HISTORIC PRESERVATION REVIEW BOARD STAFF REPORT AND RECOMMENDATION

Property Address: 2001 18th Street NW

Landmark/District: Washington Heights Historic District

H.P.A. Number: **22-227**

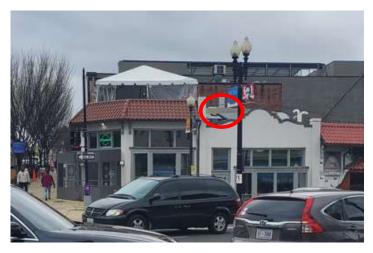
Also unpermitted is a fabric exterior vestibule and handrail at the corner entrance, for which the owner seeks after-the-fact approval. The railing lines the at-grade corner entrance, which steps down from 18th toward U Street. The enclosure is a metal framed structure with fabric walls and roof and large transparent vinyl "windows."

The front entry enclosure is also not compatible with the building's form and the streetscapes of the Washington Height Historic District. The bulky, boxy addition reads as an addition to the front of the building and blocks the view of the corner entry and its architectural features. Its scale, materials, and location are incompatible with the historic building and district. The staff has no objection to the railing that was installed, which can be seen inside the enclosure, and recommends support the for the Public Space application that is necessary for it to remain.

The HPO recommends that the Board deny the concept of a rooftop structure and exterior vestibule enclosure as inconsistent with the Act and incompatible with the character of the historic district. HPO further recommends that the Board direct the applicant to remove the unpermitted roof tent and delegate permit approval for the installed railing to staff.
